**Groat Road Bridges Rehabilitation Project:
Groat Road Bridge over the North Saskatchewan River (B059),
Groat Road Bridge over Victoria Park Road (B060) and
Emily Murphy Park Road Bridge over Groat Road (B099)
Environmental Impact Assessment**

Final Report

Re: Groat Road Bridges Rehabilitation Project: Groat Road Bridge over the North Saskatchewan River (B059), Groat Road Bridge over Victoria Park Road (B060) and Emily Murphy Park Road Bridge over Groat Road (B099) – Final Environmental Impact Assessment (EIA)

Concordance Table - Response to Comments Received: 15 May 2017

Figure 2.6
Construction Laydown Areas and Access Points

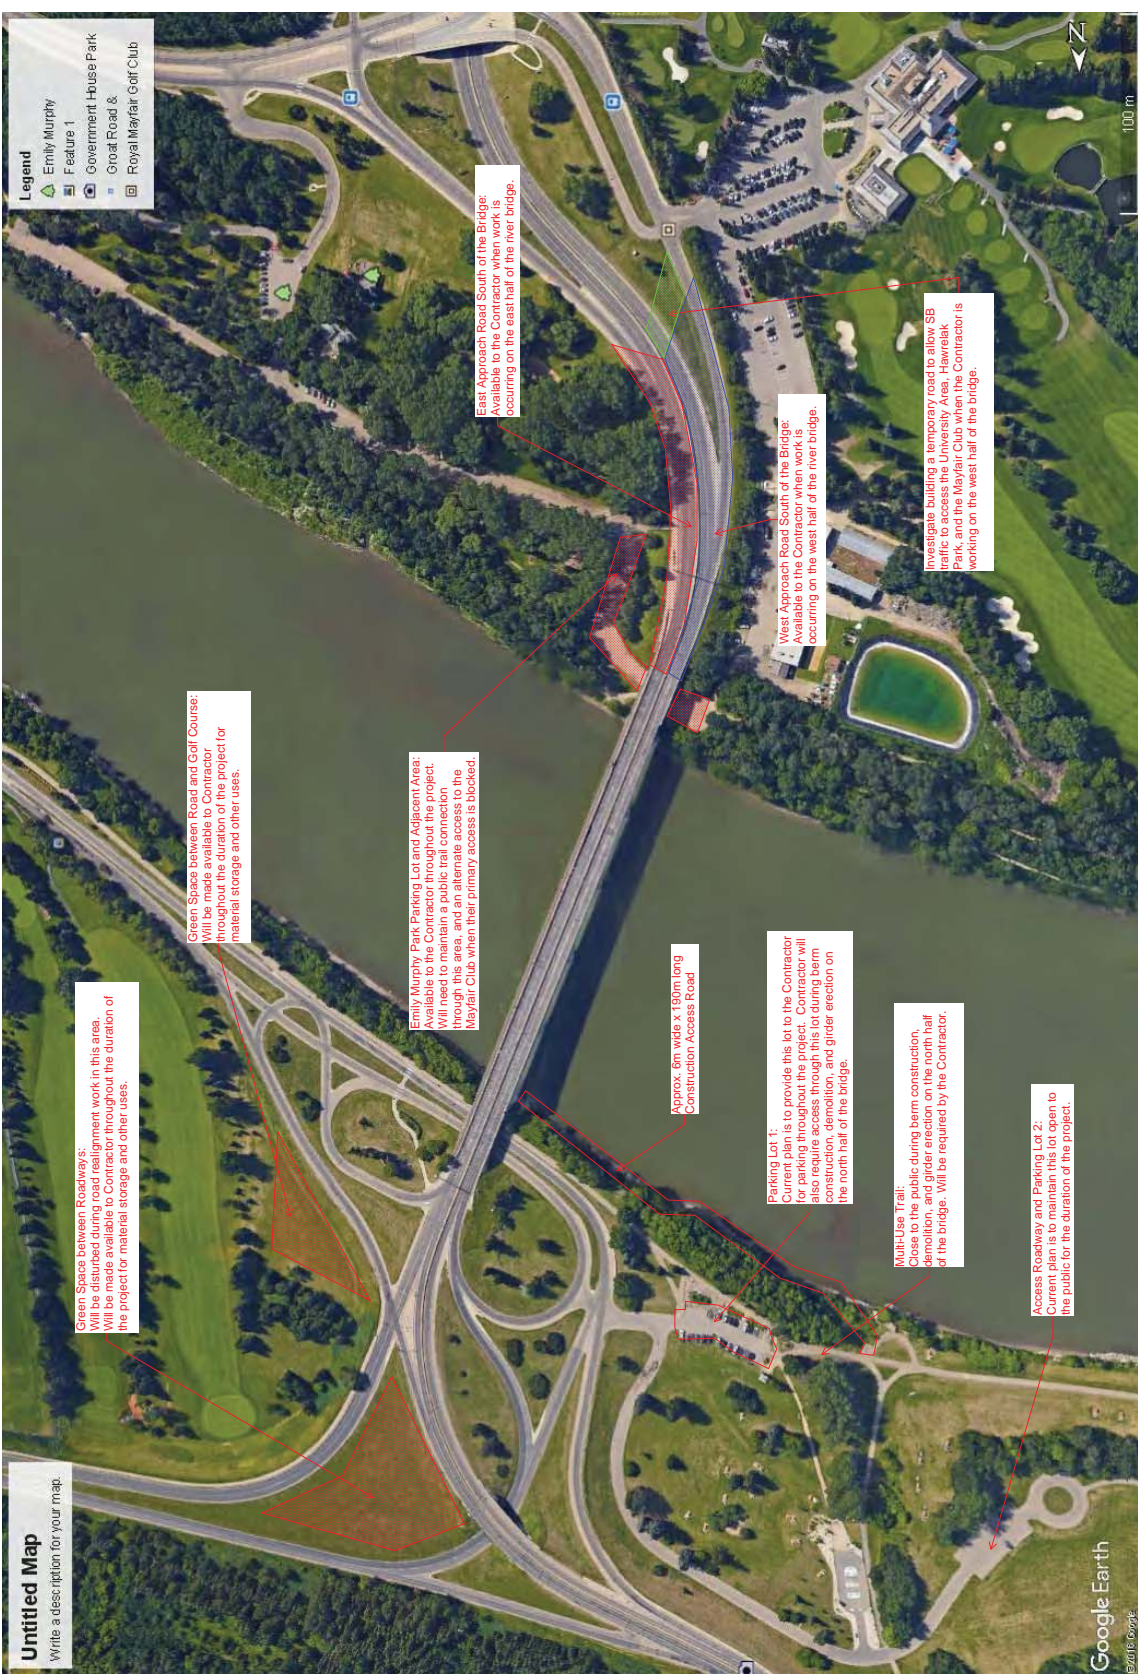
<p>Hawrelak Park</p> <ul style="list-style-type: none"> The temporary road to allow SB access to Hawrelak Park is critical, particularly to support major events in the park. 	<p>As indicated on Figure 2.6 of the draft EIA, the temporary road is intended to maintain southbound traffic access to the University Area, Hawrelak Park and Mayfair Golf Club when the contractor is working on the west half of the bridge.</p>	<p>Figure 2.6</p>
<p>Victoria Golf Course</p> <ul style="list-style-type: none"> The “study area” in one of the diagrams encompasses hole #5 and #6 in the mapping which seems inconsistent with the other plans. Please confirm that this plan was just for the EIA and not representative of the construction zone. Ensure project prepares communication plans for disruptions to golf course access and to manage traffic and/or transportation detour signage accordingly. 	<p>Confirmed. As stated in <i>Section 1.3</i> of the draft EIA, the study area presented in Figure 1.1 and used in subsequent figures was developed for the EIA to encompass direct and indirect impacts and does not represent the construction zone. Anticipated construction and staging areas are shown on Figure 5.1 (hatched areas).</p> <p>It is not anticipated that access to Victoria Golf course will be impacted as part of the bridge work. Any traffic disruptions will be communicated to stakeholders in advance with alternates/detours provided where possible. The project will work with Traffic Operations on signing all roadway and pedestrian impacts</p>	<p>N/A</p> <p>N/A</p>
